# Improved Technical Specifications

## Dresden Station

Volume 2:  
Section 3.1 and Section 3.2

FIGURE 3.4.A-1

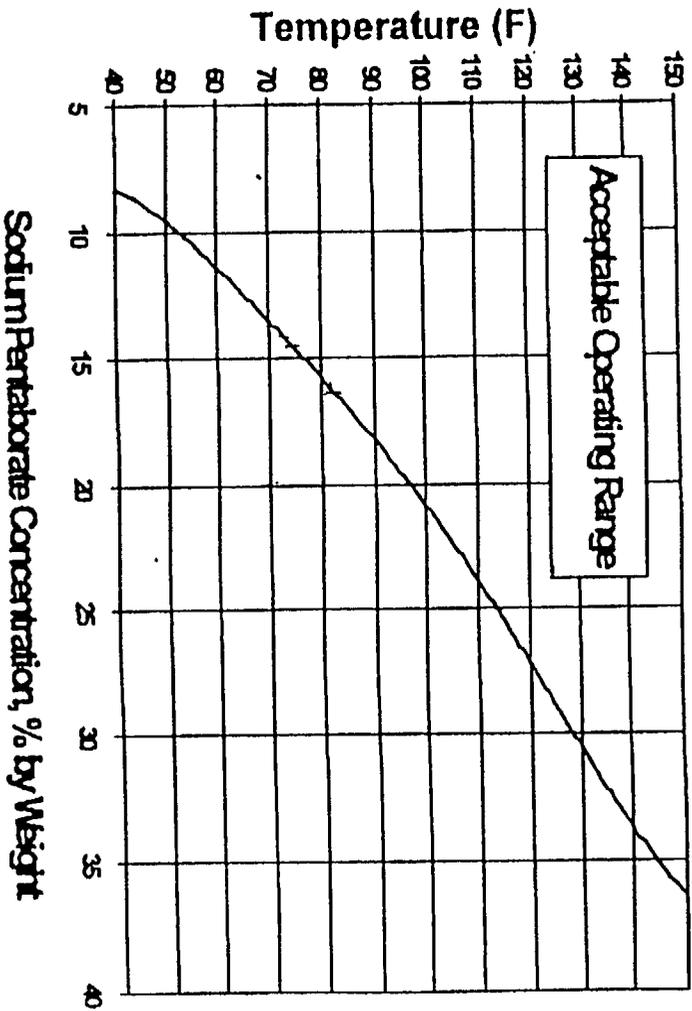
- A.3 The details of CTS 4.4.A.2.b, which identify the available boron concentration to be determined to be 14% to 16.5% by weight, are revised in proposed SR 3.1.7.5 to be within the limits of Figure 3.1.7-1. Since the limits identified in the Figure correspond to the same 14% to 16.5% by weight related to the volume requirement, this change is considered a presentation preference consistent with the BWR ISTS, NUREG-1433, Rev. 1. Therefore, this change is administrative.

- M.2 (cont'd) Figure 3.1.7-2 (CTS Figure 3.4.A-1). This change is considered more restrictive since an explicit Surveillance will be required whenever the limits of Figure 3.1.7-2 are not met. However, this change is necessary since precipitation of the boron from solution may occur when the temperature requirements are not met.

Figure 3.1.7-2

Insert Figure 3.1.7-2

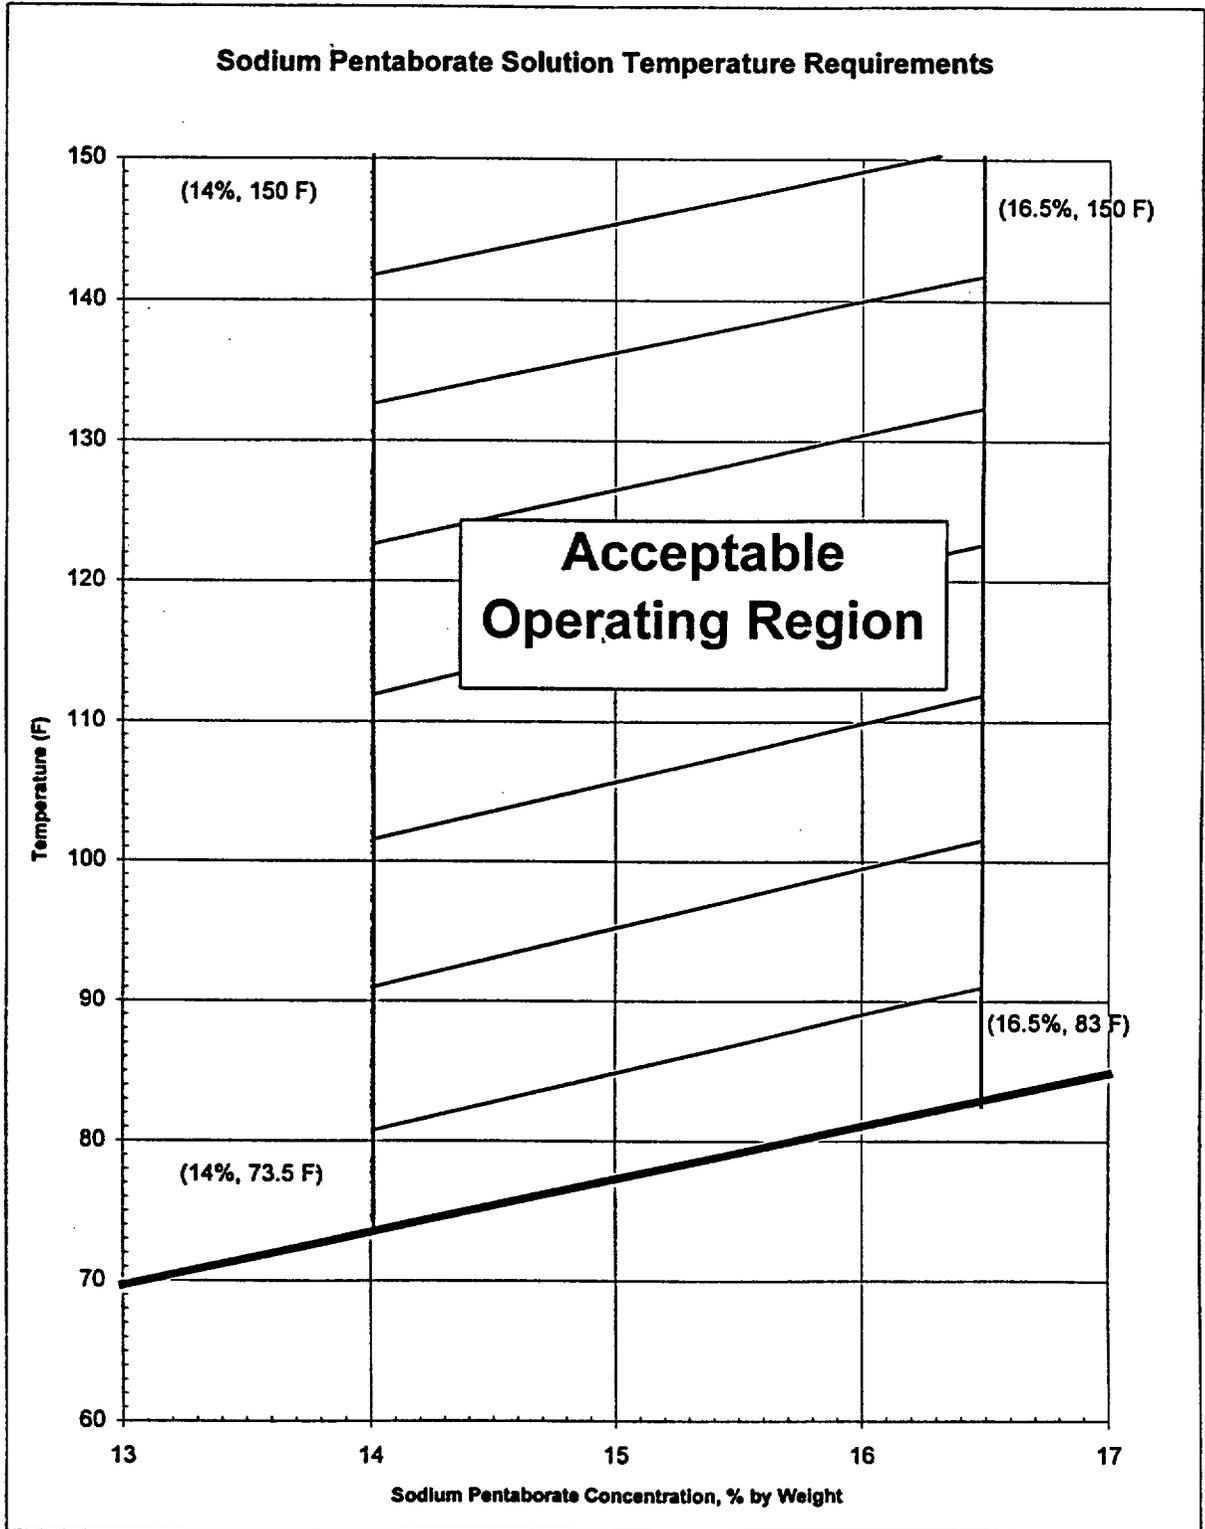
2. The brackets have been removed and the proper plant specific information/value has been provided.
3. The proper Dresden 2 and 3 nomenclature has been used (CTS Figures 3.4.A-1 and 3.4.A-2). This is also consistent with the nomenclature used in SR 3.1.7.1 and SR 3.1.7.2.
